Random Misfire Under High Load

Service Category Engine/Hybrid System

Section Engine Control

| YEAR(S) | MODEL(S) | ADDITIONAL INFORMATION |
|---------|----------|------------------------------|
| 2018 | Camry | WMI(s): 4T1 VDS(s): BZ1HK |

Figure 1. Location of Authorized Modifications Label on 2018 Camry

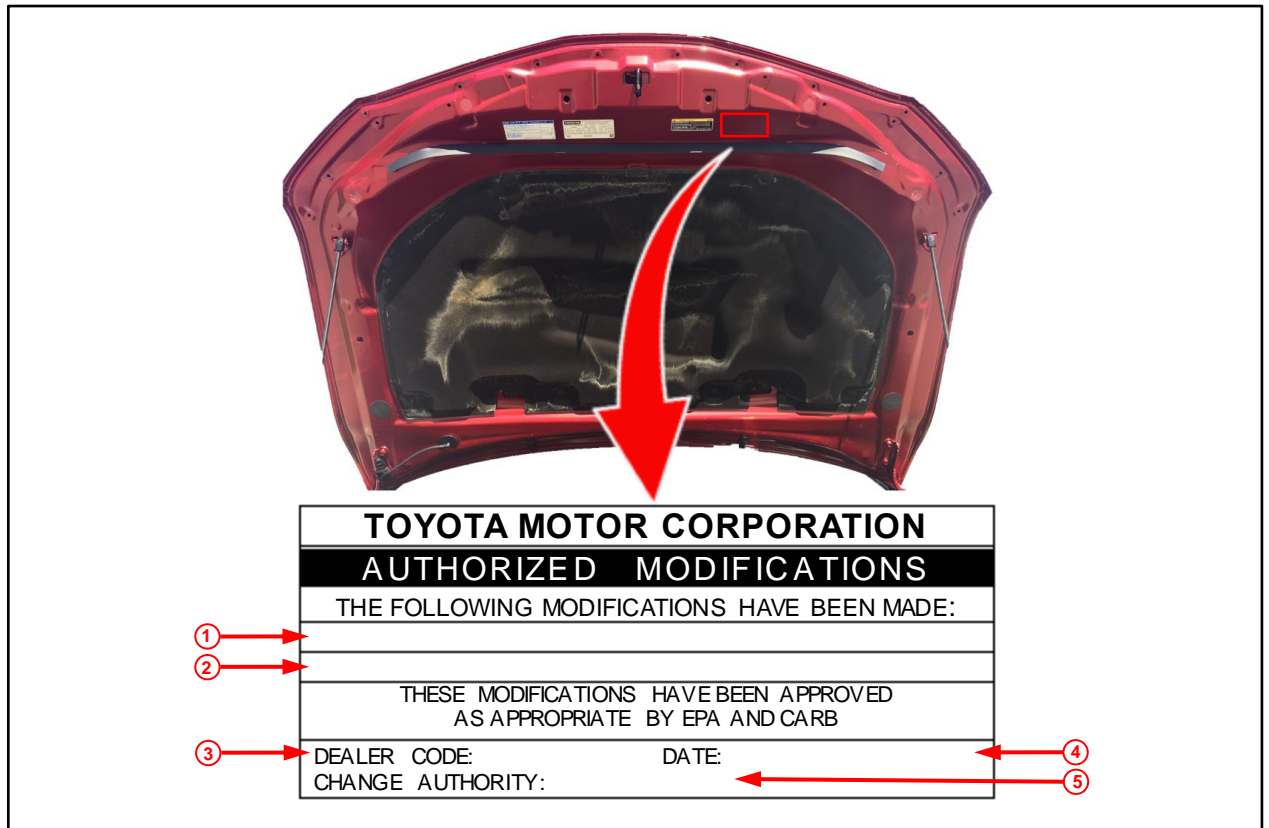
- Check for the Authorized Modifications Label affixed to the vehicle in the locations shown below. Confirm if the ECM (PCM) calibration has been updated.

4. Prepare and install the Authorized Modifications Label.

B. Install the Authorized Modifications Label onto the vehicle at the location shown in Figure 1. The Authorized Modifications Label is available through the MDC, P/N 00451-00001-LBL.
